SUBJECT: Forwards Rev 2 of marked-up draft Tech Specs App A, Sections 1, 2, 3, 4, 5 & 6. Util review has been incorporated to ensure that rev addresses Unit 2 uniquely & meets requirements of STS, NUREG-0123.

Docket No. 50-397

Subject: NUCLEAR PROJECT NO. 2  
DRAFT TECHNICAL SPECIFICATIONS,  
REVISION 2, SUBMITTAL OF

**FIGURE 3.1.5-1**

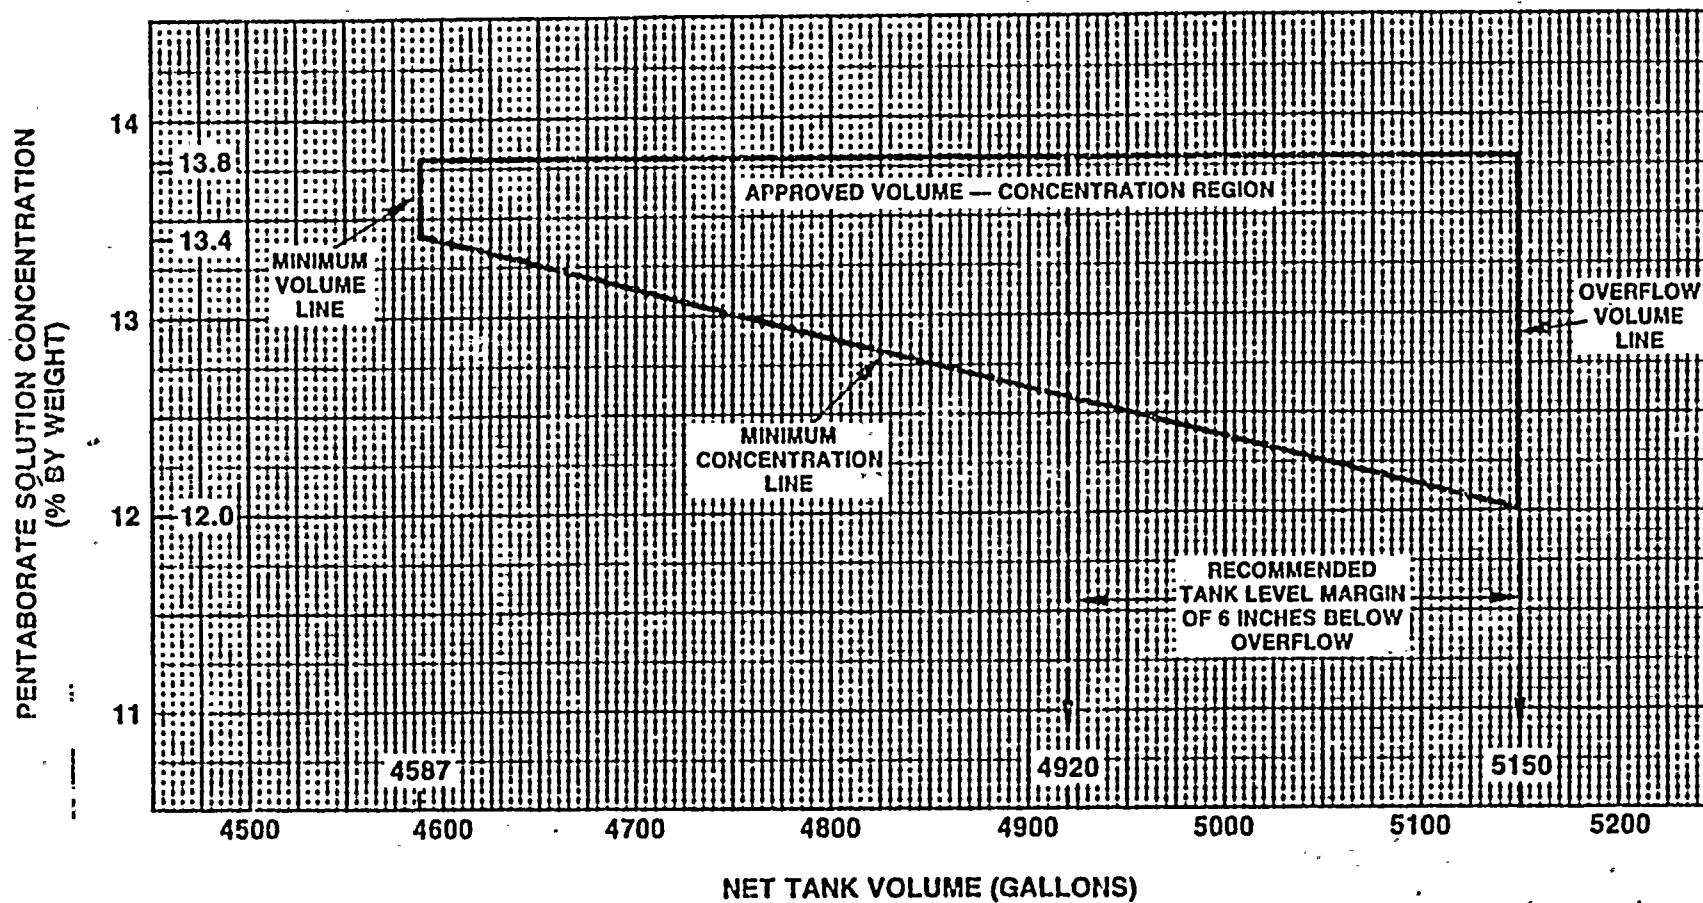
d.2) The safety relief valve setting is 11400 psig to insure an injection pressure of 1220 psig and protect the piping which is rated at 1540 psig. The change is intended to accurately reflect both concerns

d.4) The heat up rate is determined during a startup test. To preclude completion of the test impacting tech. spec. submittal, the method employed by LaSalle has been adopted.

FIGURE 3.2.3-1

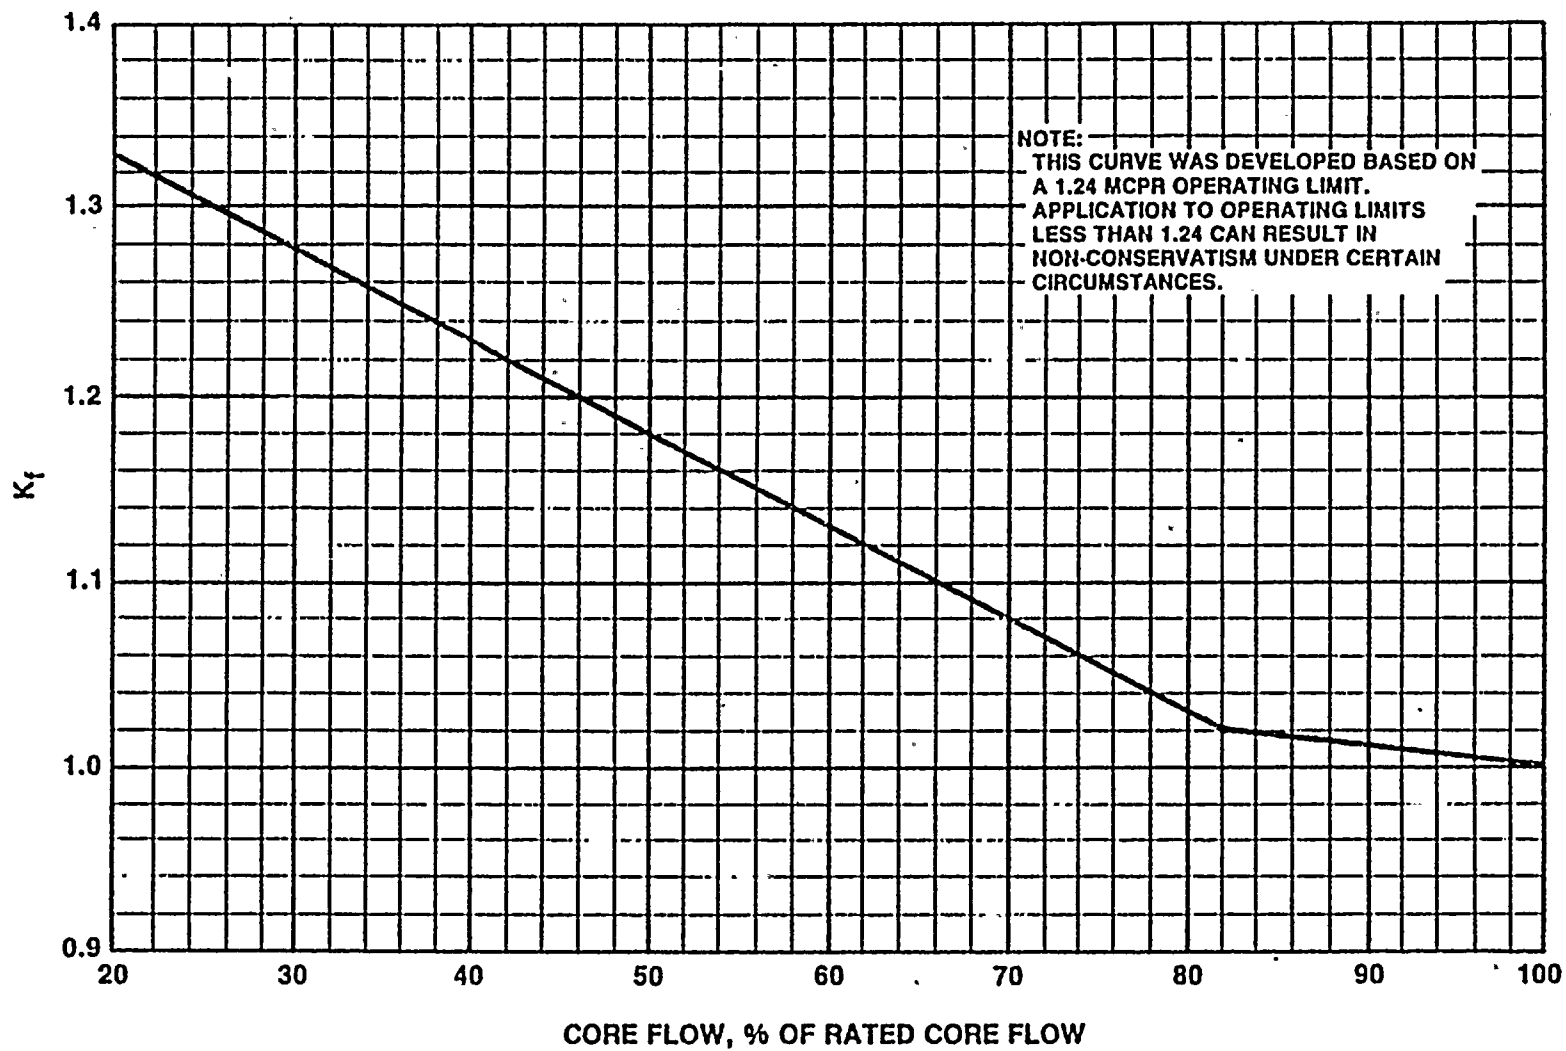
3.2.3 The MINIMUM CRITICAL POWER RATIO (MCPR) shall be equal to or greater than the MCPR limit times the  $K_f$  determined from Figure 3.2.3-1, ~~(provided that the end-of-cycle recirculation pump trip (EOC-RPT) system is OPERABLE per Specification 3.3.4.2), with MCPR for 8 x 8 fuel = 1.24 for two(2) recirculation loop operation. The MCPR limit is to be increased by (later) for single recirculation loop operation.~~  
APPLICABILITY: OPERATIONAL CONDITION 1, when THERMAL POWER is greater than or equal to 25% of RATED THERMAL POWER.

Delete

~~(c. With the end-of-cycle recirculation pump trip system inoperable per Specification 3.3.4.2, operation may continue and the provisions of Specification 3.0.4 are not applicable provided that, within one hour, MCPR is determined to be equal to or greater than the MCPR limit times the  $K_f$  determined from Figure 3.2.3-1, from:~~

X With MCPR less than the MCPR limit times  $K_f$  determined from Figure 3.2.3-1, initiate corrective action within 15 minutes and restore MCPR to within the required limit within 2 hours or reduce THERMAL POWER to less than 25% of RATED THERMAL POWER within the next 4 hours.

- 1) Standard LCO wording applies to G.E. BWR-6 product lines. Appropriate BWR-5 product line (WNP-2 plant specific) wording has been substituted.
- 2) The provision for EOC-RPT instrumentation operability was deleted because it was more correctly addressed by LCO 3/4.3.4.2
- 3) A plant specific analysis has been completed for single noise loop operation which justifies the modification.
- 4) The action statement concerning EOC-RPT inoperability was deleted because it was more correctly addressed by LCO 3/4.3.4.2

FIGURE 3.9.7-1

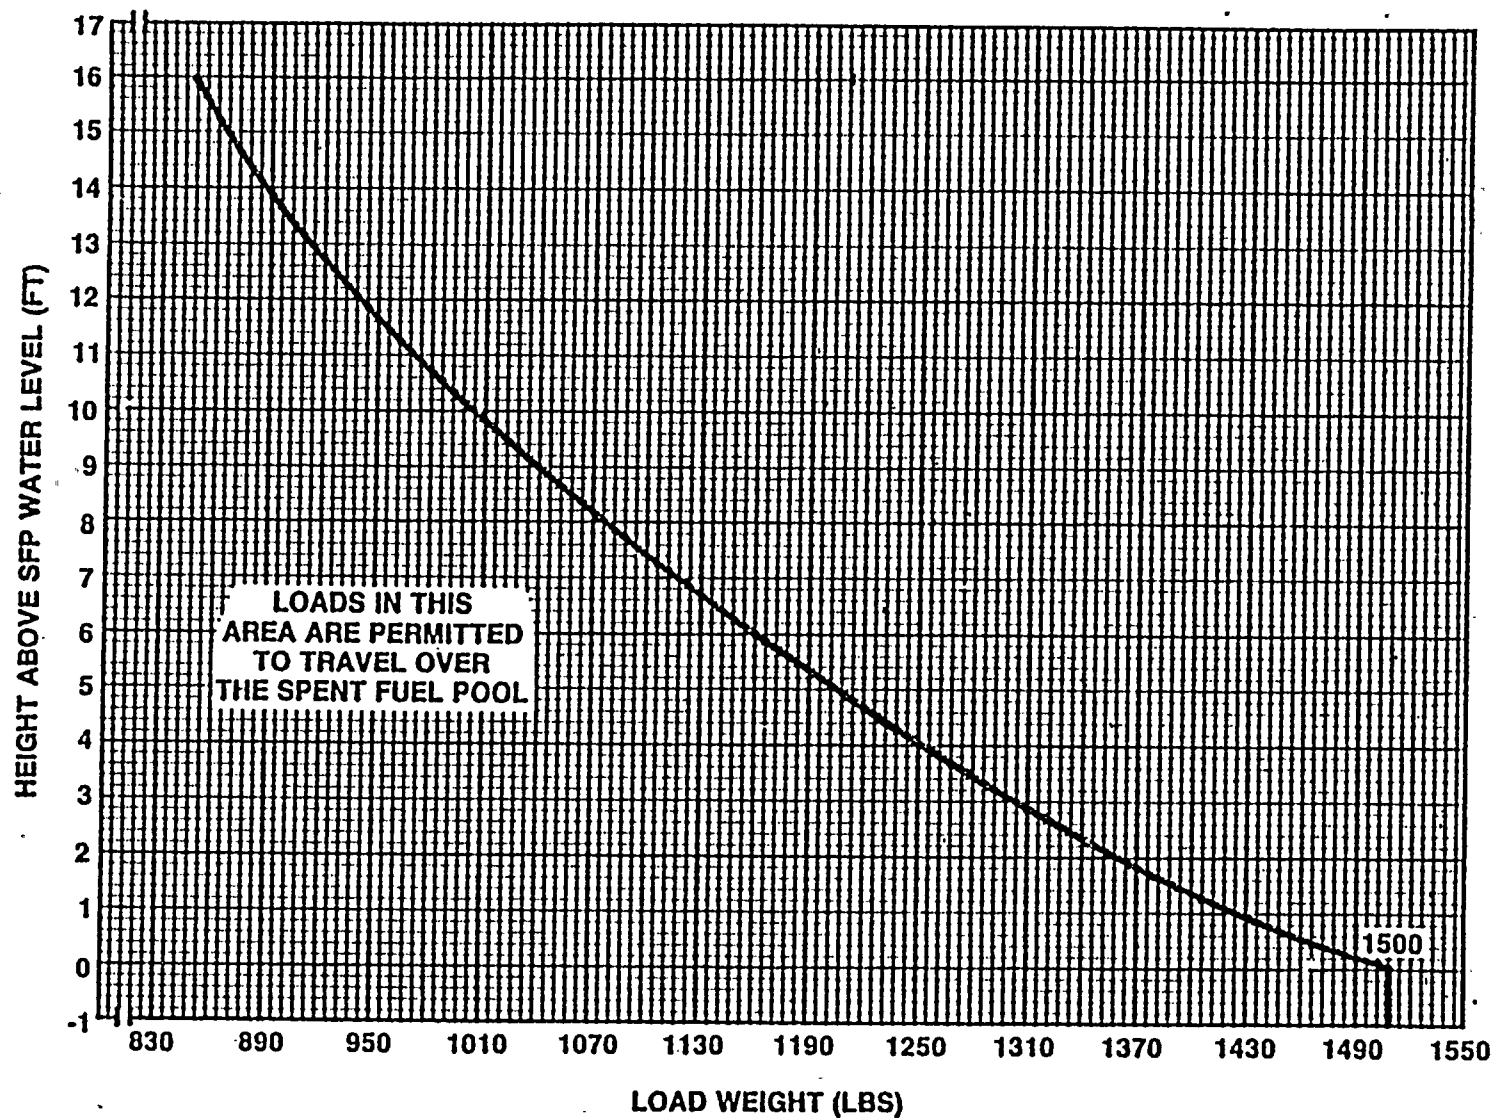
3.9.7 Loads up to 1500 pounds may be permitted to travel over fuel assemblies in the spent fuel storage pool racks provided that the height of the load above the surface of the pool water is limited per Figure 3.9.7-1. Land weight

4.9.7 Crane interlocks <sup>load limits per Figure 3.9.7-1</sup> and physical stops which prevent crane travel with loads in excess of ~~1500 pounds~~ over fuel assemblies in the spent fuel storage pool racks shall be demonstrated OPERABLE within 7 days prior to and at least once per 7 days during crane operation.

**FIGURE 5.1.1-1**

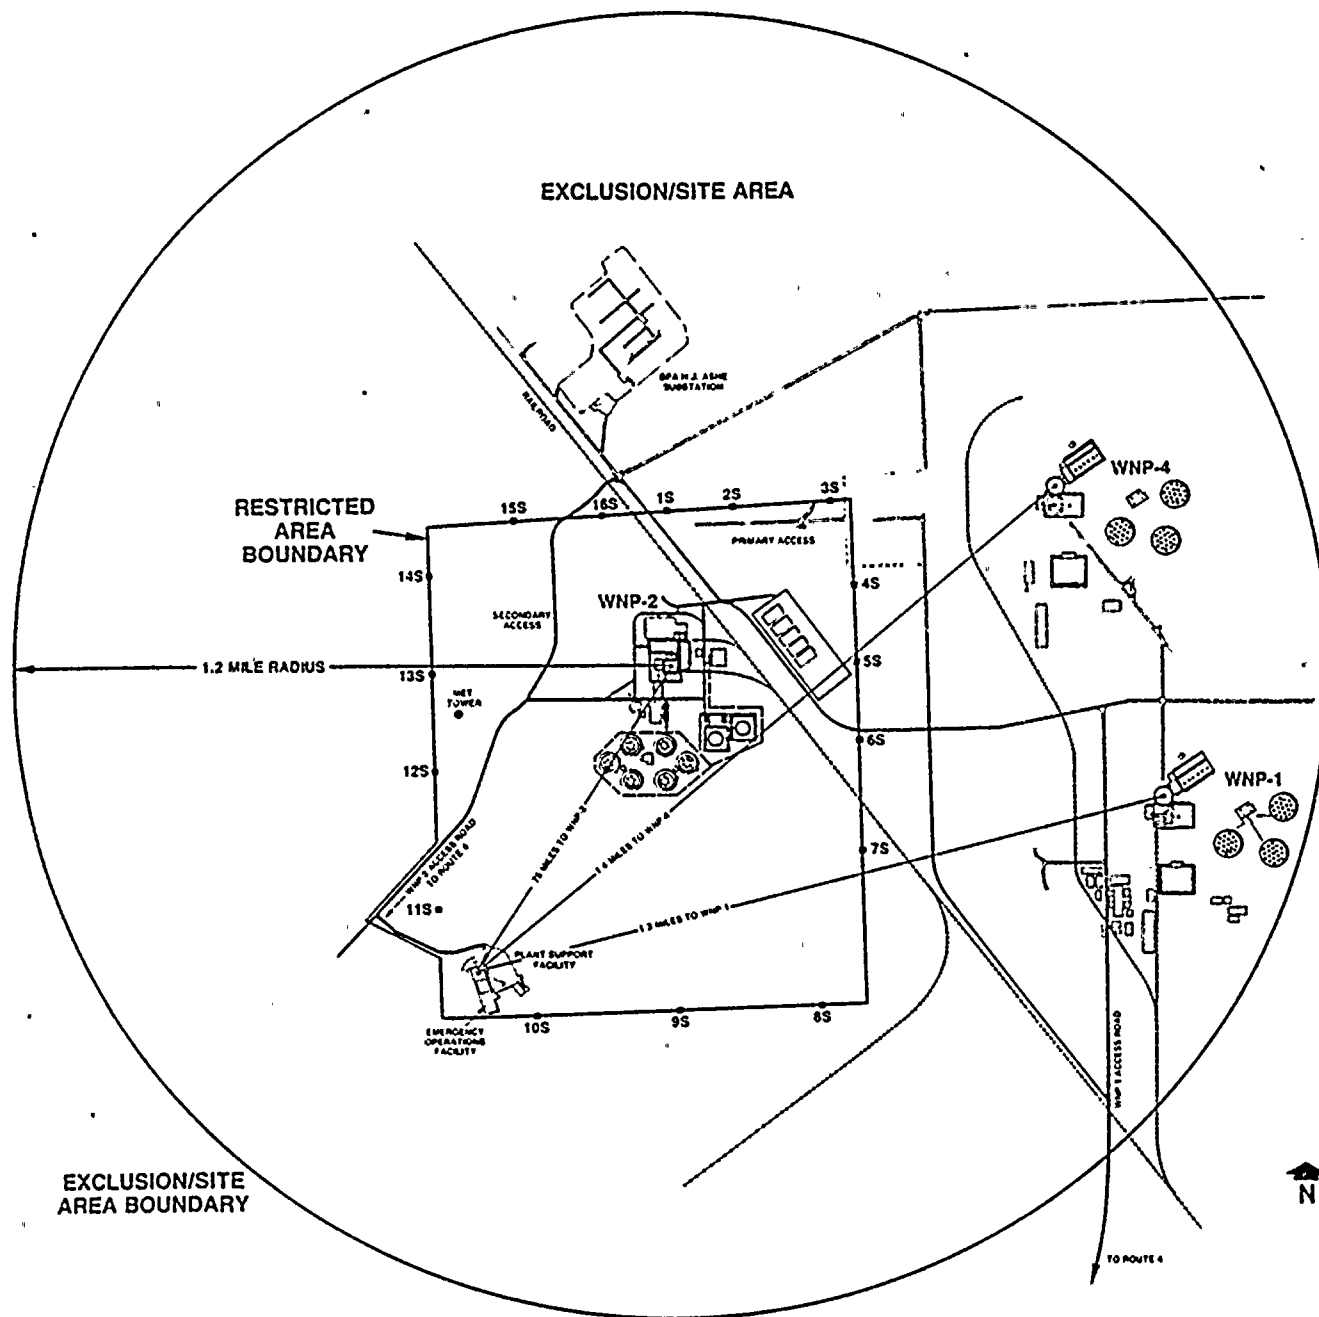
Add :

Restricted Area

S.1.3 The Restricted Area ~~will~~ be ~~shown~~ as shown in figure
